Appl. No. 10/626,136  
Amdt. dated January 5, 2005  
Reply to Office action of October 6, 2004

**Amendments to the Drawings:**

OPENER FOR PULL TOP-TYPE CANS  
(Sheet with changes)

FIG. 4

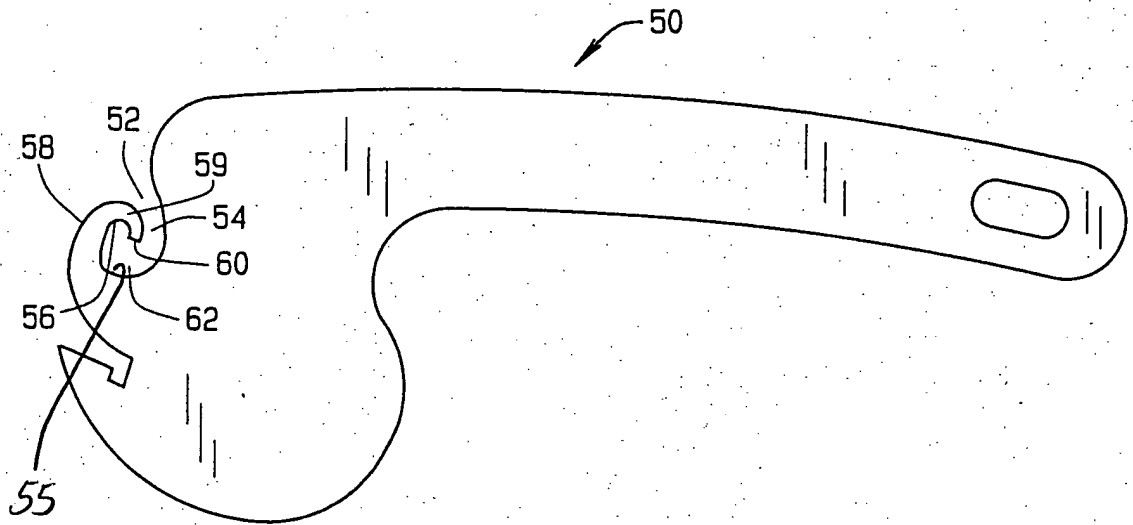
The amendments to the specification add reference numbers to FIGS. 4, 6 and 7. Two sheets of corrected drawings containing FIGS. 4-7 are filed herewith containing corrected drawings. Also enclosed are two sheets of drawings showing the added reference numbers in red.

The attached two sheets of drawings includes changes to Figs. 4, 6 and 7. These sheets, which include Fig. 4-7, replaces the original sheets containing Figs. 4-7. Also attached are two sheets of drawings showing, in red ink, the changes made to FIGS. 4, 6 and 7.
